Project	<b>IEEE 802.16 Broadband Wireless Access Working Group</b> < <a href="http://ieee802.org/16">http://ieee802.org/16</a> >	
Title	<b>Pilot Allocation in Downlink PUSC</b>	
Date Submitted	<b>2004-08-24</b>	
Source(s)	Ran Yaniv, Tal Kaitz, Naftali Chayat, Vladimir Yanover, Marianna Goldhammer  <b>Alvarion Ltd.</b>	Voice: +972-37674583  mailto: <a href="mailto:ran.yaniv@alvarion.com">ran.yaniv@alvarion.com</a>
	Wonil Roh, JeongTae Oh, Chan-Byoung Chae, Kyunbyoung Ko, Hongsil Jeong, Sung-Ryul Yun  <b>Samsung Electronics Co., Ltd.</b>	mailto: <a href="mailto:wonil.roh@samsung.com">wonil.roh@samsung.com</a>
Re:	Ballot #14c	
Abstract		
Purpose	Adopt proposed changes to TGe document	
Notice	This document has been prepared to assist IEEE 802.16. It is offered as a basis for discussion and is not binding on the contributing individual(s) or organization(s). The material in this document is subject to change in form and content after further study. The contributor(s) reserve(s) the right to add, amend or withdraw material contained herein.

# Pilot Allocation in Downlink PUSC

**Figure 1 – Current definition of DL PUSC clusters for 2-antenna STC**

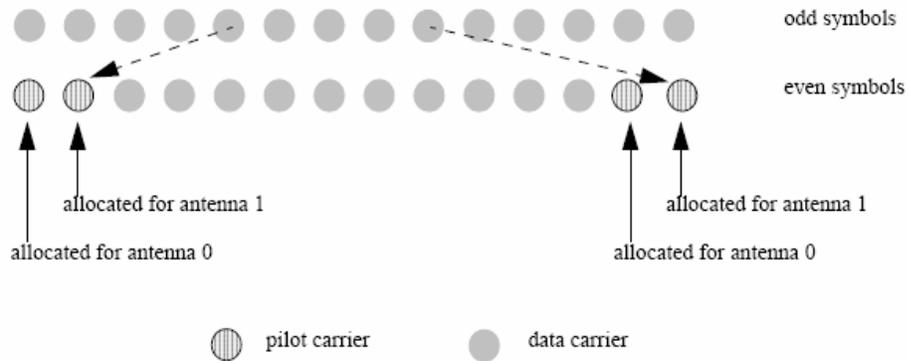
A fundamental problem exists in the current definition of pilot locations in the downlink-PUSC STC mode [1]. Figure 1 shows the current structure of a cluster pair (i.e. clusters in two consecutive symbols) for the case of 2-antenna STC:

The pilot spacing of 12 subcarriers leads to very significant channel estimation loss in the presence of channels with relatively high delay spread (delay spread that is however much smaller than the maximum supported cyclic prefix length) when using pilot-aided estimation approaches. Since the goal of STC schemes is to extend the cell range, it is important that they operate well at cell edges, where high delay spread is very likely. Note that in STC mode we can not rely on channel estimation from the DL preamble since the preamble is transmitted by only one antenna.

In effect, estimation loss in highly dispersive channels will severely limit data transfer rate to as low as QPSK modulation using  $\frac{1}{4}$  coding rate, regardless of thermal noise level. A solution to this problem is presented in section 2. A by-product of this solution is the fact that two contiguous symbols, rather than slots, can be STC encoded – this is beneficial in situations where the channel is time-varying.

Figure 6 - Comparison between current and proposed DL PUSC structures in STC mode,

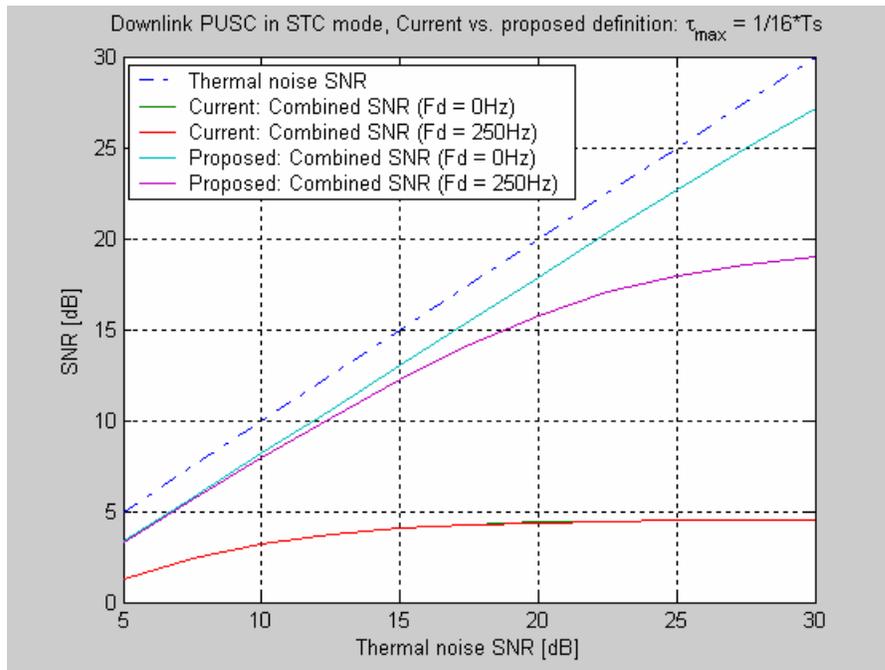
The proposed cluster structure does indeed solve the severe estimation problem for the PUSC STC modes. This is shown in Figure 6 and Figure 7.

[Figure 245a – structure of PUSC clusters in 2-antenna STC mode for FFT sizes below 2048](#)

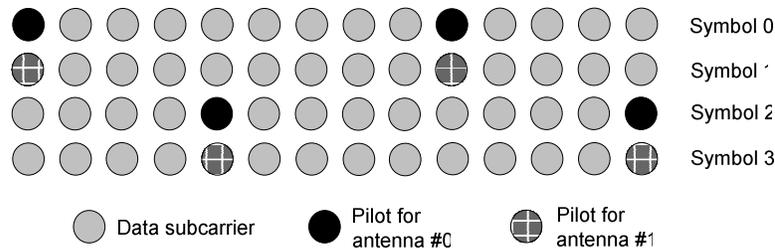
*[Add figure 245a and accompanying caption on page 584 following figure 245]*

In PUSC the data allocation to cluster is changed ([Figure 245](#)) to accommodate two antennas transmission ~~with the same estimation capabilities,~~ each cluster shall be transmitted ~~twice from each antenna~~ [from both antennas](#).

The clusters composing the subchannels used by the STC mode shall be allocated and subcarriers numbered as defined in 8.4.6.2 [with pilots in each consecutive pair / quartet of PUSC symbols allocated as depicted in figure 245 for FFT-2048 / figure 245a for FFT sizes below 2048](#). ~~The cluster structure of the subchannels allocated for STC is slightly modified to fit the STC requirements. The structure shall be modified as depicted in Figure 245 (switching 2 pilot carriers from the odd symbol with 2 data carriers from the even symbols, switching of the data carriers and the pilots carriers shall be performed after constellation mapping, therefore maintaining all the encoding scheme and the subchannel allocation scheme).~~ [For FFT-2048, switching 2 pilot carriers from the odd symbol with 2 data carriers from the even symbols is performed \(switching of the data carriers and the pilots carriers shall be performed after constellation mapping, therefore maintaining all the encoding scheme and the subchannel allocation scheme\).](#) In this scheme, transmission on regular subchannels and STC subchannels is possible and is determined by the MAC layer (the allocation is performed by allocating major groups of subchannels for regular or STC transmission). ~~The transmission STC encoding of the data shall be performed in pairs of symbols as illustrated in Figure 246 for FFT-2048 and in Figure 246a for FFT sizes below 2048. The number of OFDMA symbols in a PUSC STC-encoded allocation shall be a multiple of four.~~

[Figure 246a – STC usage with PUSC for FFT sizes below 2048](#)

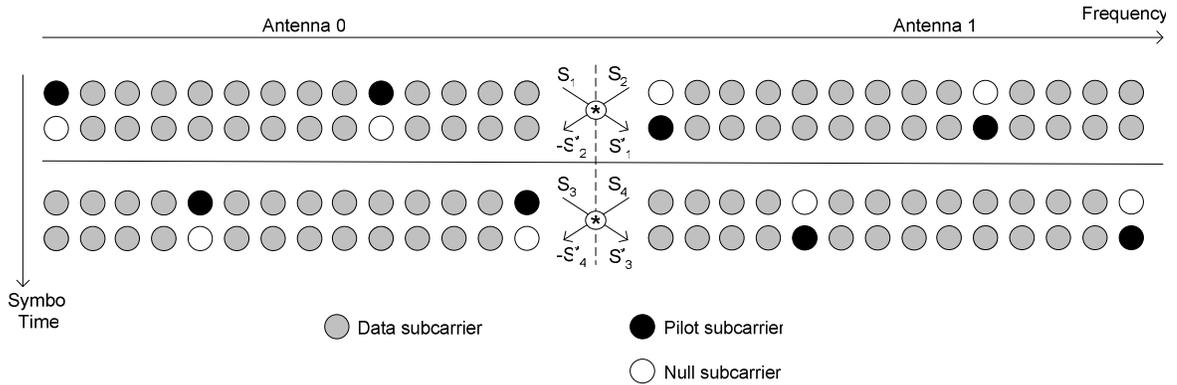
[Add figure 246a on page 584 following figure 246:]

[Figure 251a – structure of clusters in the 4-antenna STC mode for FFT sizes below 2048](#)

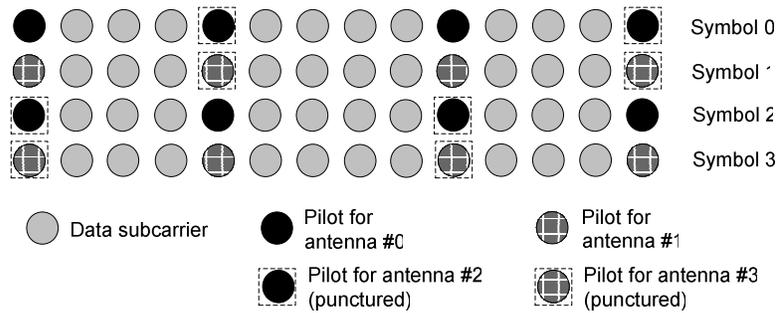
[Add figure 251a on page 589 following figure 251:]

~~For For~~ this configuration the basic cluster structure is changed ~~as indicated in Figure 251 to accommodate accommodate~~ the transmission from 4 antennas ~~(pilots for antennas 2/3 override data subcarriers in the even symbols, switching and erasing of the data subcarriers shall be performed after constellation mapping, therefore maintaining all the encoding scheme and the subchannel allocation scheme),~~ as indicated for FFT-2048 in Figure 251 and for FFT sizes below 2048 in Figure 251a. ~~For FFT-2048, pilots and data subcarriers are switched as in the 2-antenna STC mode, and pilots for antennas 2/3 override data subcarriers in the odd symbols. For FFT sizes below 2048, pilots for antennas 2/3 override data subcarriers as depicted in figure 251a. Switching and erasing of data subcarriers shall be performed after constellation mapping, therefore maintaining all the encoding scheme and the subchannel allocation scheme as in the 2-antenna STC mode).~~

[Figure 234a – structure of PUSC clusters for FFT sizes below 2048](#)

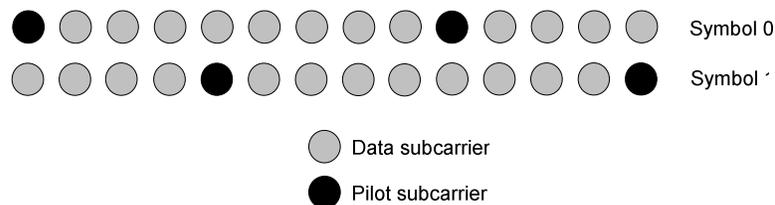
*In light of the change to pilot allocation in STC mode (figures 245a and 251a), it is desirable (from implementation point of view) to make a slight modification to the pilot locations so that the same subcarrier permutation generator can be applied during both STC and non-STC subchannel allocation procedures. This can be achieved if in both STC and non-STC modes, the pilots are located either at locations 1 & 10 or at locations 5 & 14. The proposed change does not affect channel estimation performance.*

*[Add figure 234a on page 567 following figure 234:]*

Figure 234 depicts the cluster [structure for FFT-2048](#), and figure 234a depicts the cluster structure for [FFT sizes below 2048](#):
